Service Bulletin

Category 4	Applicable Model/s 1988-89 626/MX-6 (w/o Turbo)	Subject IDLE SPEED FLUCTUATION OR HUNTING	Bulletin No. 056/89 Issued 4/24/89 Revised 6/30/89
---------------	---	--	--

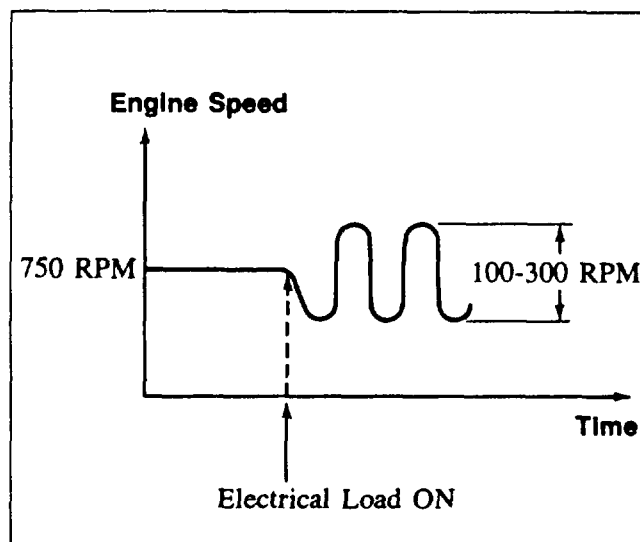
Idle speed fluctuation or hunting may occur when the electrical load such as headlights, rear defroster and so on are turned on while idling. This condition likely occurs easily if the idle speed is adjusted too low.

If you encounter a customer with a 1988-1989 626/MX-6 MTX complaining of idle fluctuation or similar complaint, adjust the idle speed according to the following repair procedure.

1. Warm up the engine and check that the idle speed is within the specification.

★ **Idle Speed: 750 ± 25 RPM**
(in Neutral, with Test Connector grounded)

2. With the test connector NOT grounded, check for a fluctuation in the idle when the head lights and rear defroster are turned "ON". If fluctuation is present, ground the test connector and adjust the idle speed to 950 – 1000 RPM (in neutral with the parking brake applied).*
